PART 1 - REVISED DOCUMENTS ISSUED WITH THIS ADDENDUM**1.1 REVISED SPECIFICATIONS AND OTHER PROJECT MANUAL DOCUMENTS**

END OF ADDENDUM NO. 2

HURON-CLINTON METROPOLITAN AUTHORITY
STONY CREEK LANDING
AEW PROJECT #0215-0038

SHEET TITLE:
**INTERIOR
ELEVATIONS**

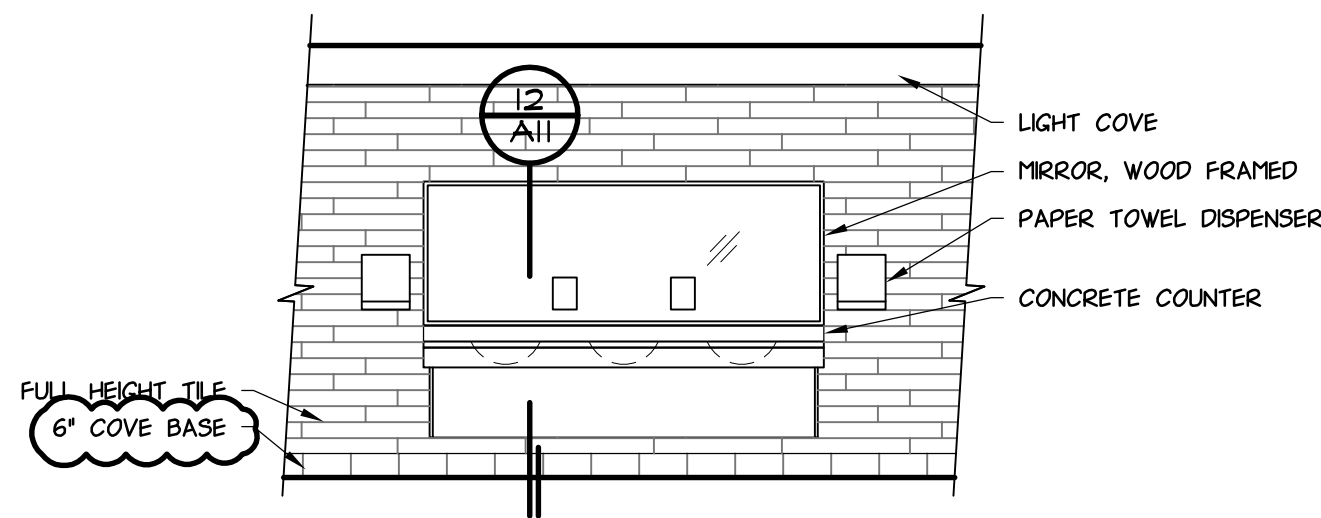
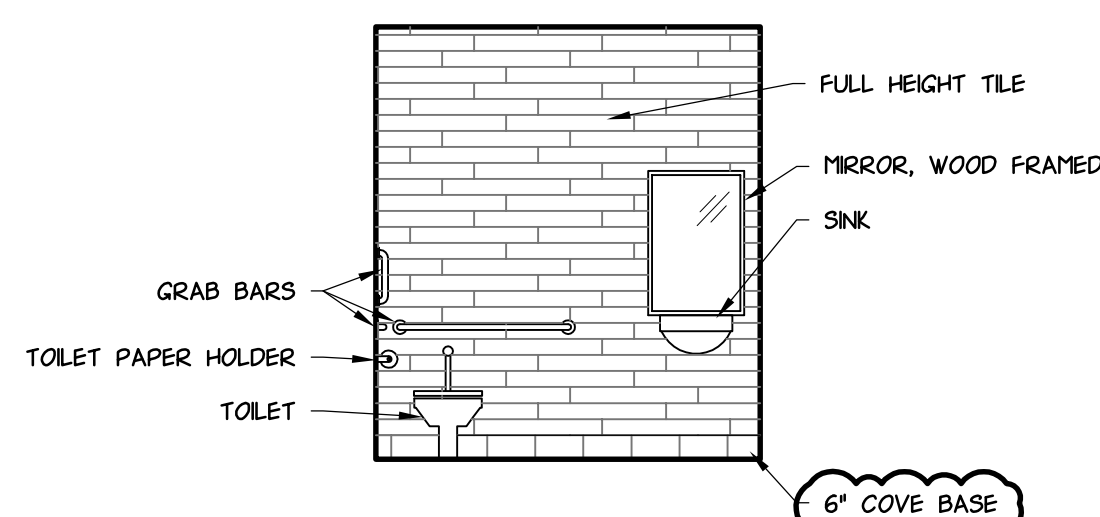
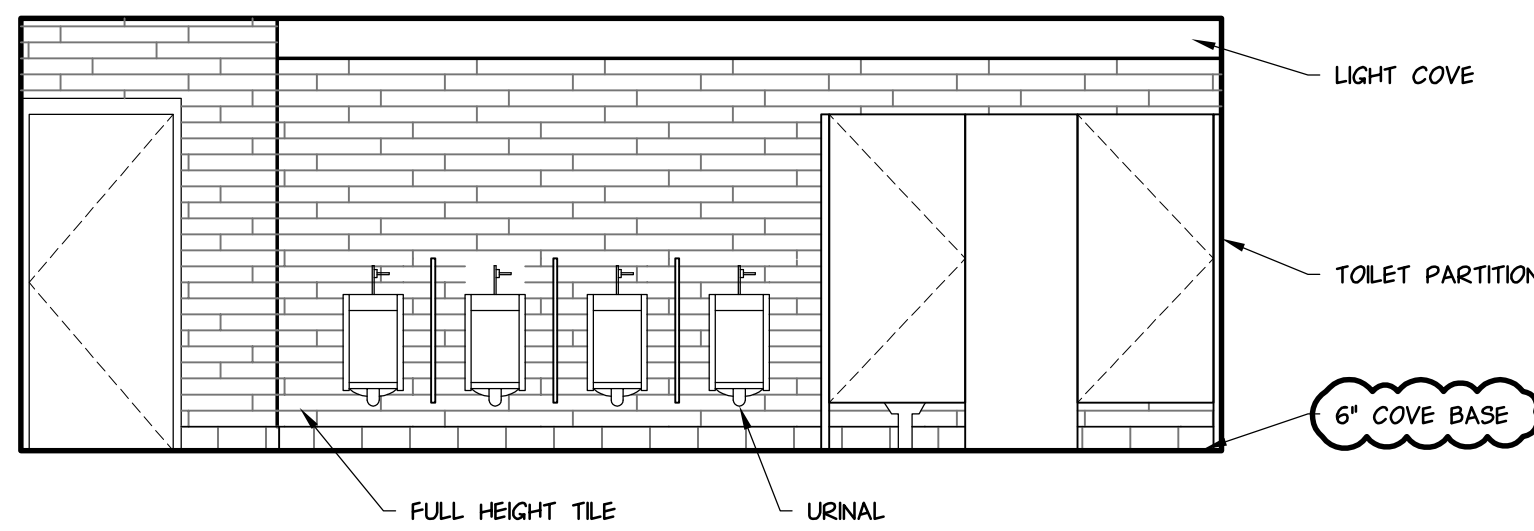
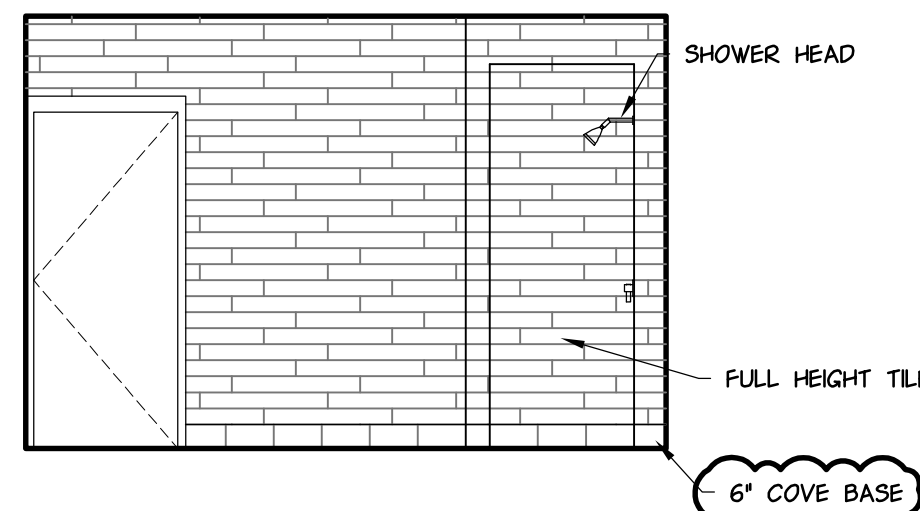
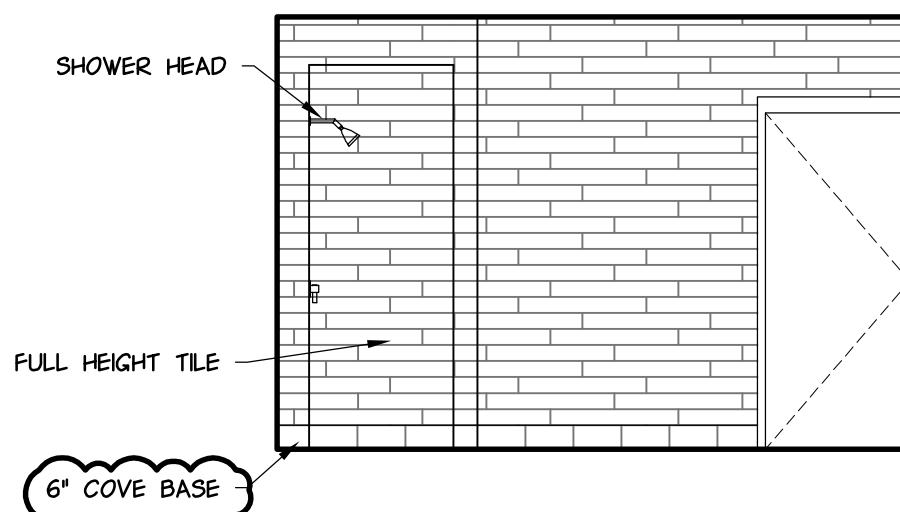
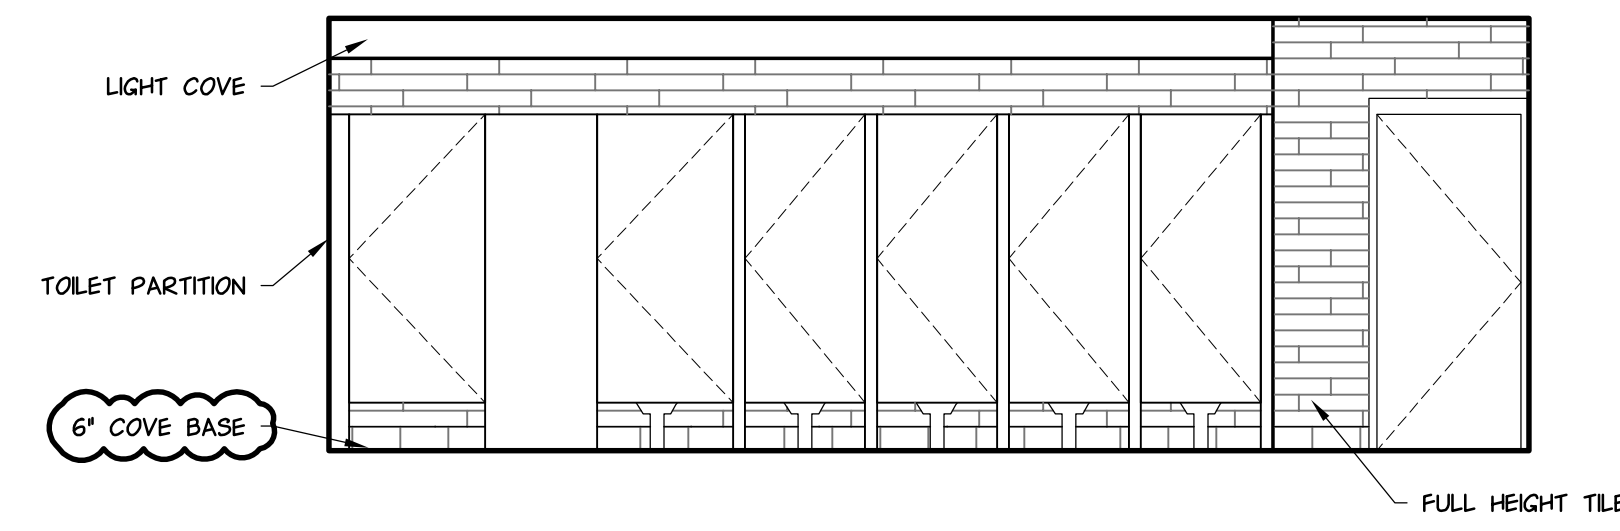
SHEET NUMBER A9 – Interior Elevations

This sheet shows a change to Elevations to display the six inch tile cove base.
